LOT 9 PARKER POINTE

LOT 10, PARKER POINTE FILING NO. 1

COVER SHEET

SITE PLAN

LANDSCAPE PLAN

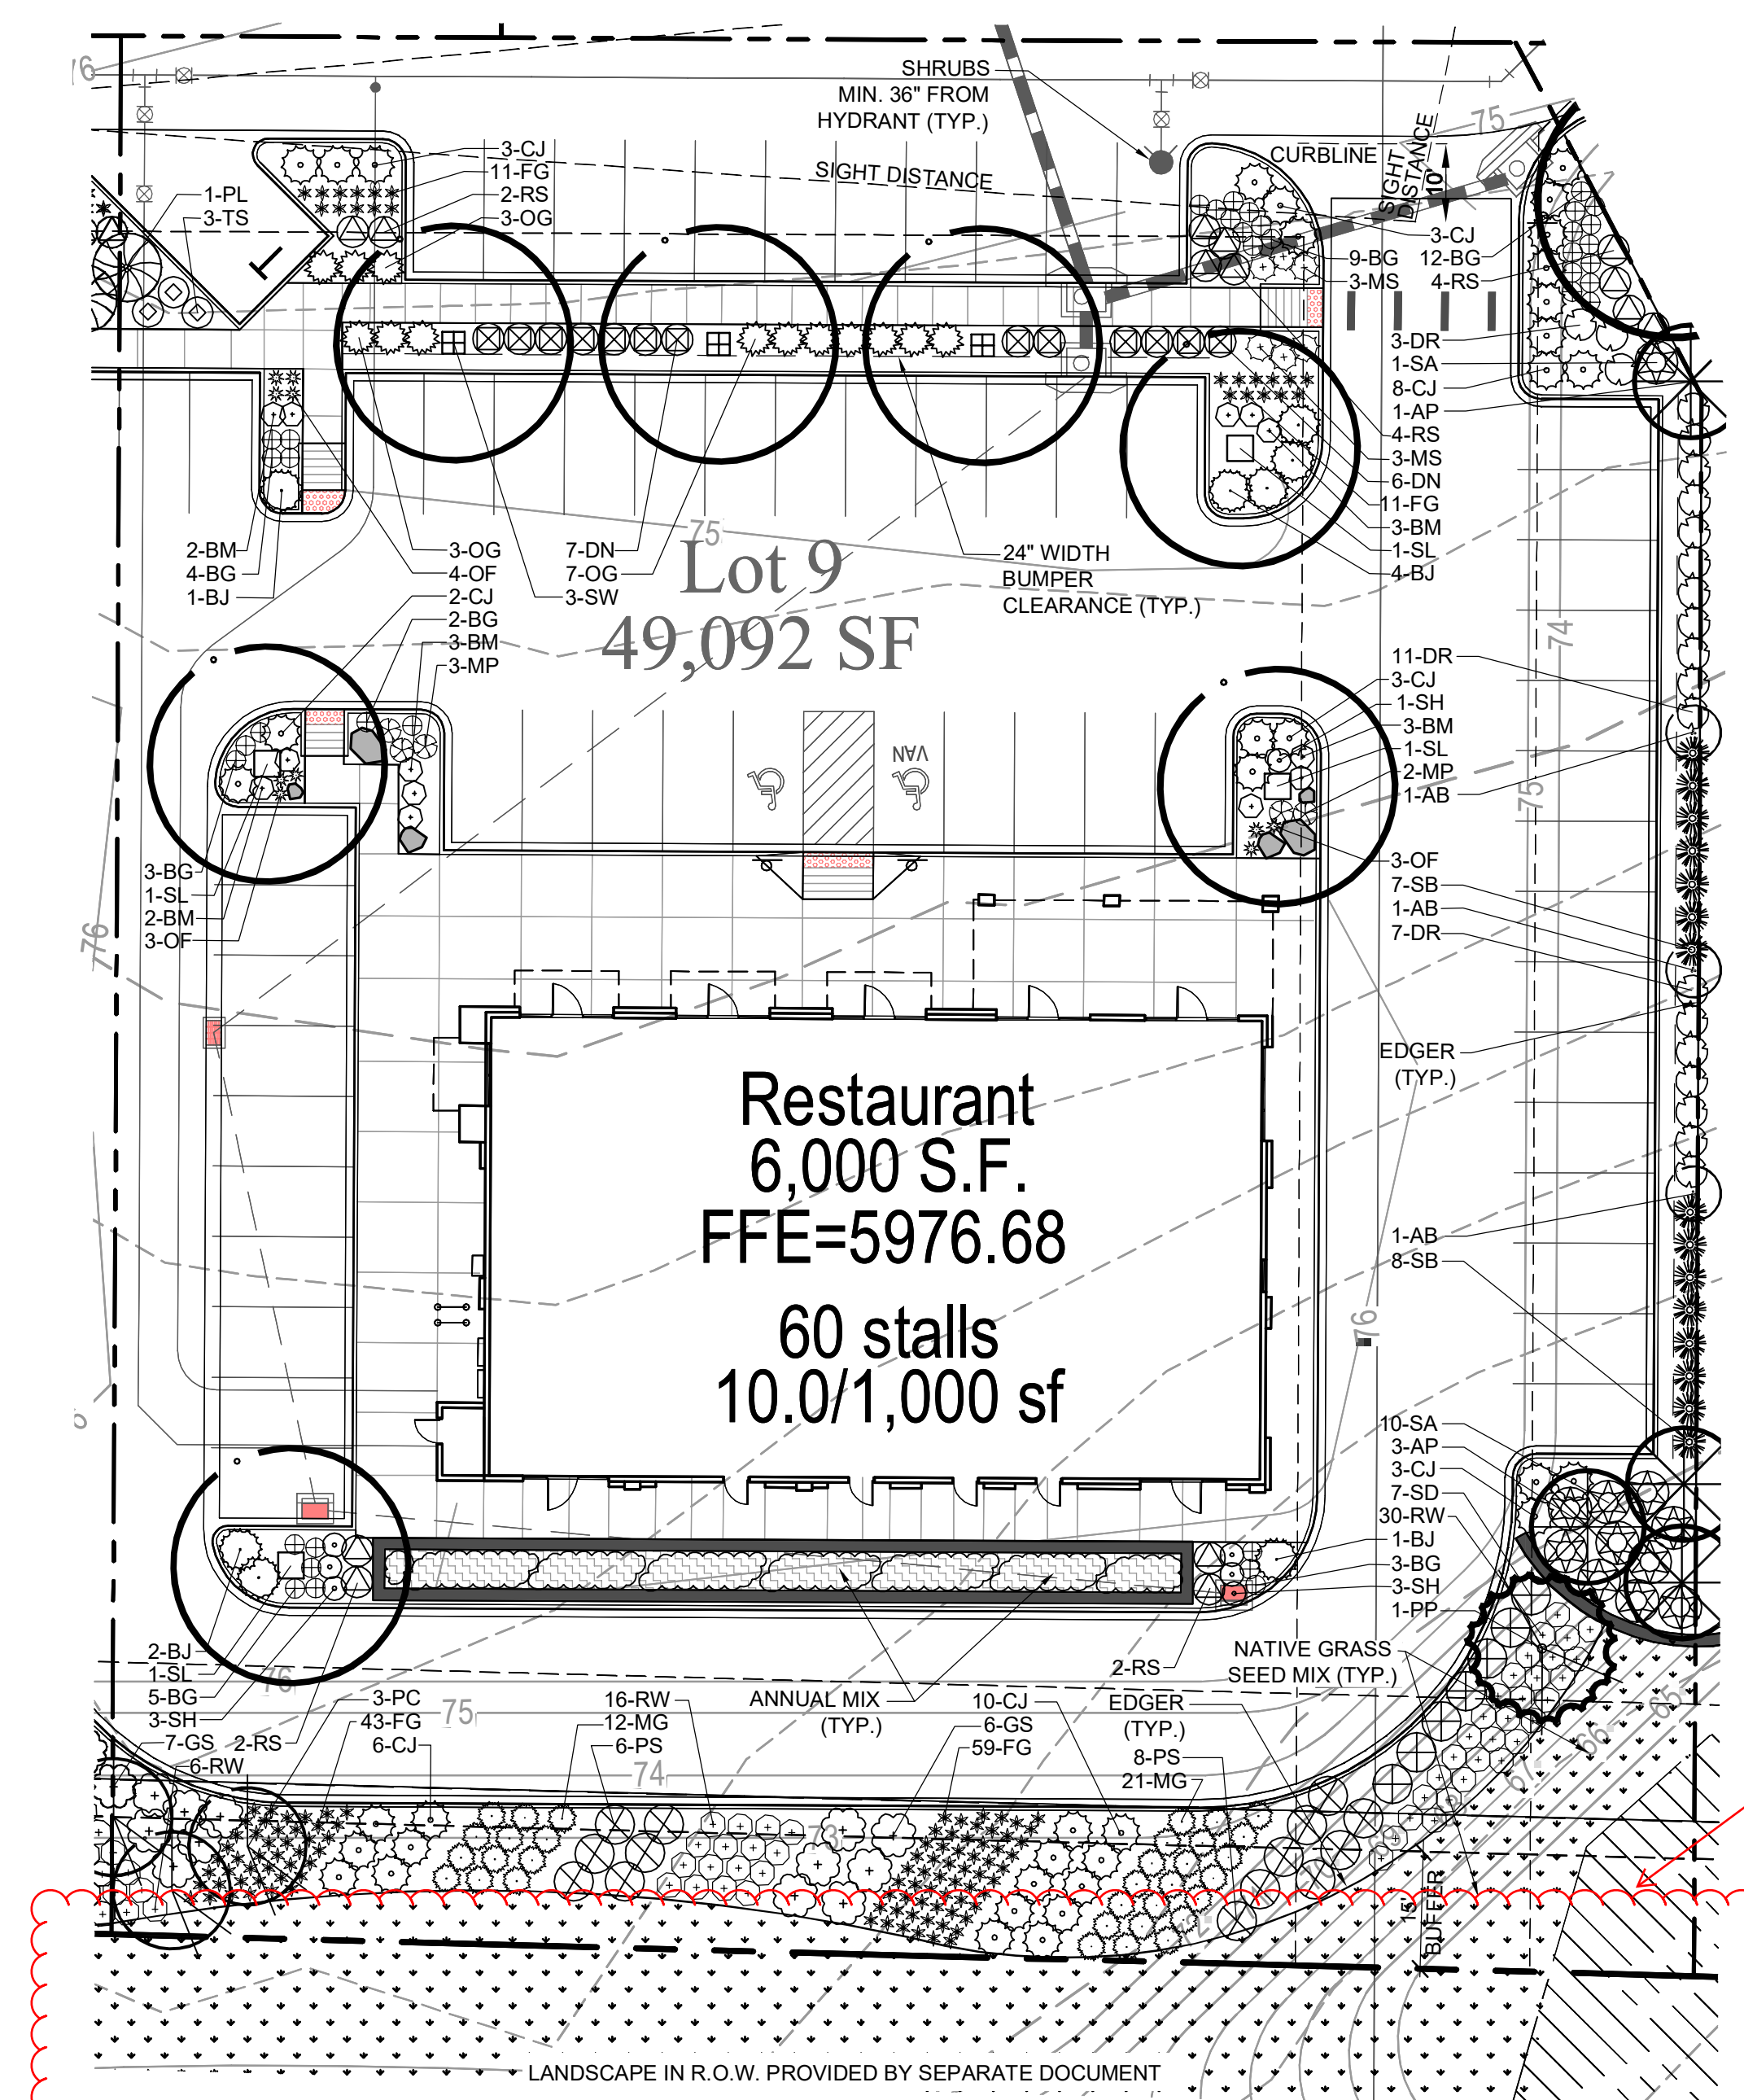
These calculations cannot include any annual or perennial plants. Please clarify with a note on the landscape plan that these calculations do not include annuals.

These calculations appear to address 13.06.070 (1) (2) which requires that 75% of landscape calculation be living material. This means that 25% of overall may be non-living material, i.e. utility equipment, boulders, and open rock mulch areas. Please revise calculation to remove non-living material from the calculation.

These calculation may need revision per comments on sheet 2 Site Plan regarding streetscape requirements. Additionally, staff only counts 3 trees, of the SW variety. If the SL variety is included as the fourth tree, it is a parking lot tree, not a streetscape. Deciduous streetscape trees are required to be 2.5 caliper

Perimeter landscape is in addition to streetscape required on the east property boundary. Please revise to include perimeter landscaping for the eastern edge.

Landscaping within ROW may not be counted toward on site landscape requirements. Please verify that this area has not been included in calculations and provide a note that states such.

This signature block is not needed for the landscape plan as part of the site plan. Site Plans are administratively approved. This signature may be required as part of the CD's but should be removed from the site plan set.

01 EAST ELEVATION
SCALE: 1/8" = 1'-0"

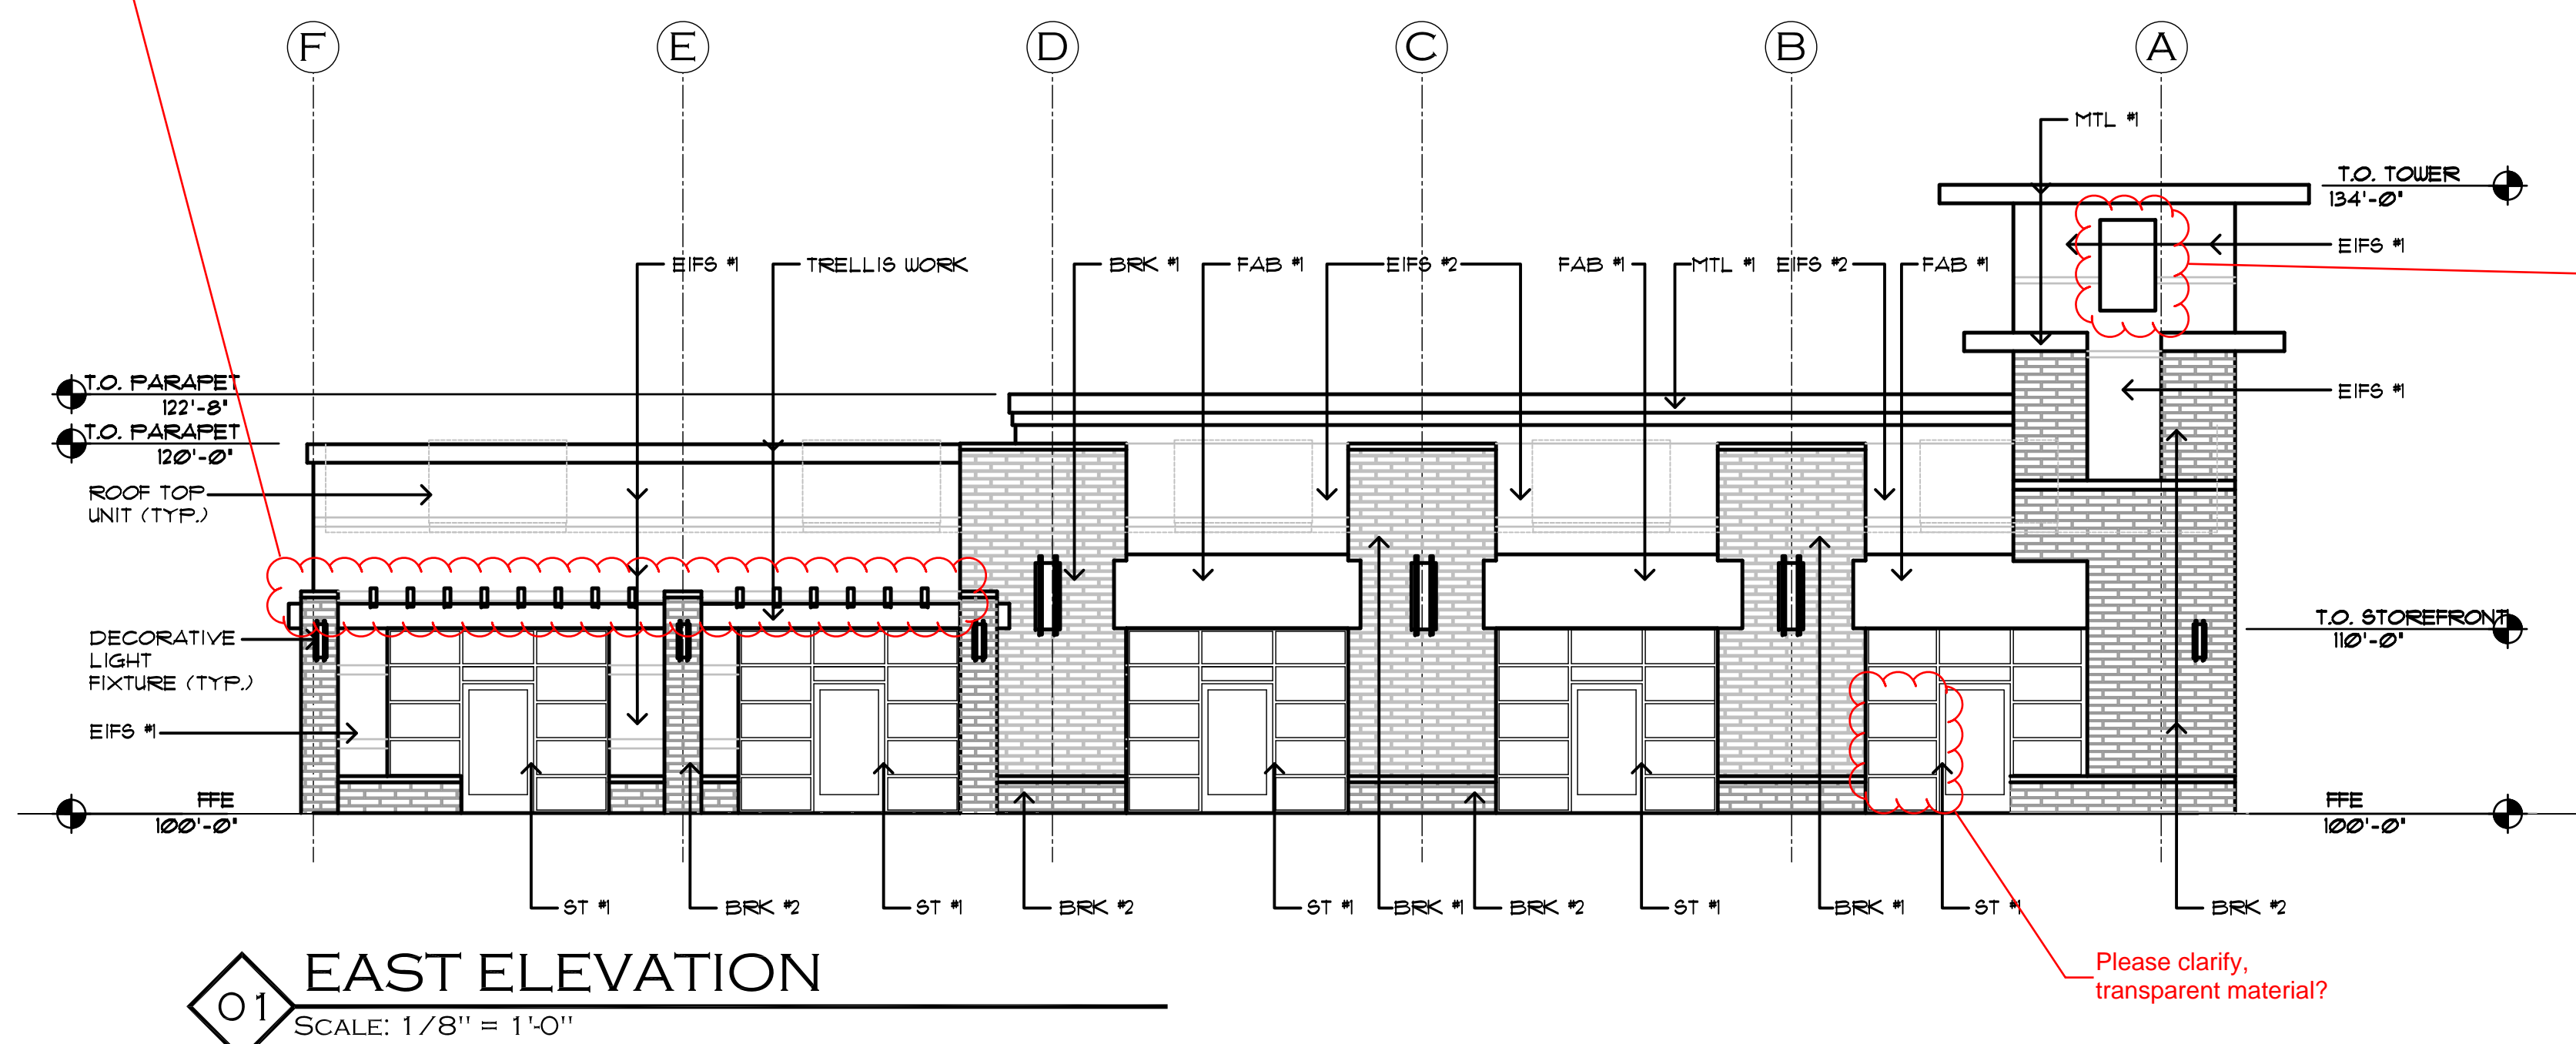
Site plan layout does not reflect a drive up layout. Site plan has been reviewed without consideration for a drive up window. Please clarify and make revisions as needed.

Need detail of planter box shown on west elevation.

Please call out all transparency on building and add to material table.

Need detail of cornice

Need detail of trellis. Also material proposed, not shown in materials table. Need a physical material sample of trellis material.

01 WEST ELEVATION
 SCALE: 1/8" = 1'-0"

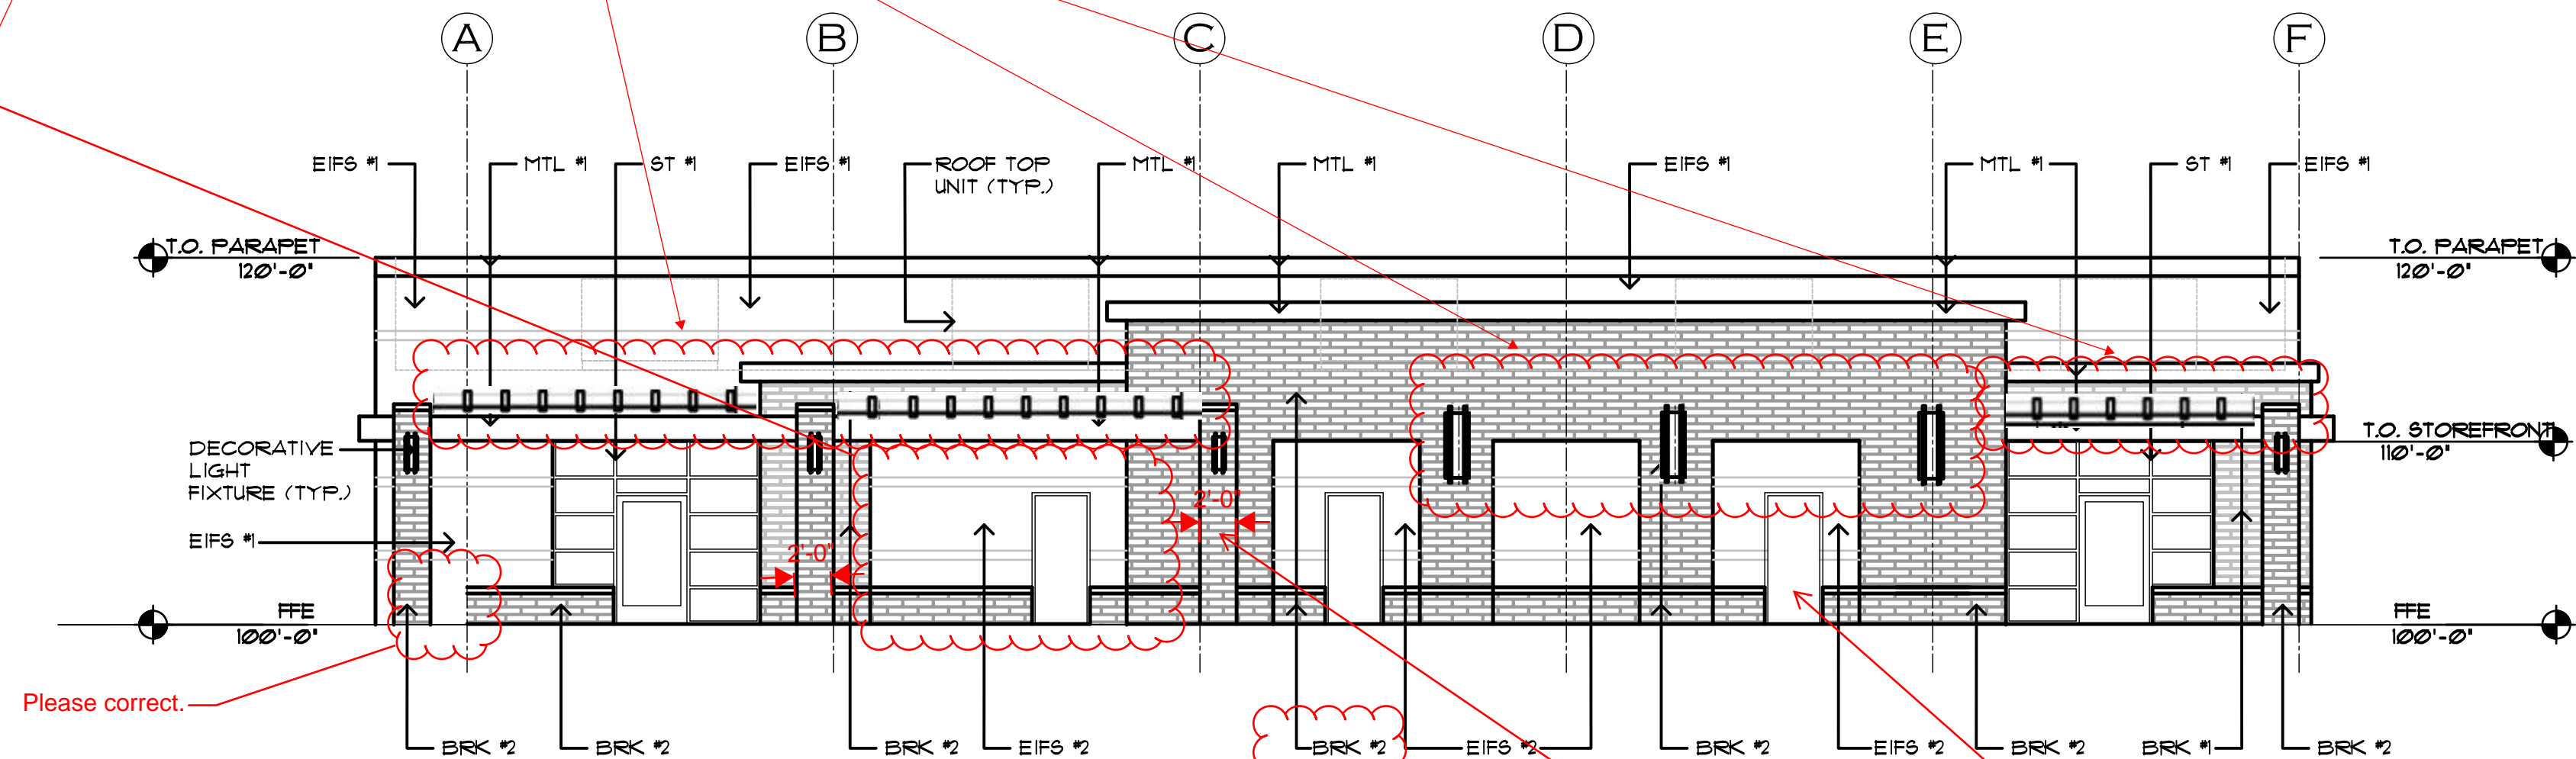
West elevation architecture reflects "back of house". Needs to reflect front or east elevation elements more closely. Faux trellis may be one way. Addition of exterior lighting may be another. Please review mock up below. Tower is not shown

EIFS is not a quality material. Consider other decorative treatment for areas where EIFS is shown.

Please call out on all elevations.
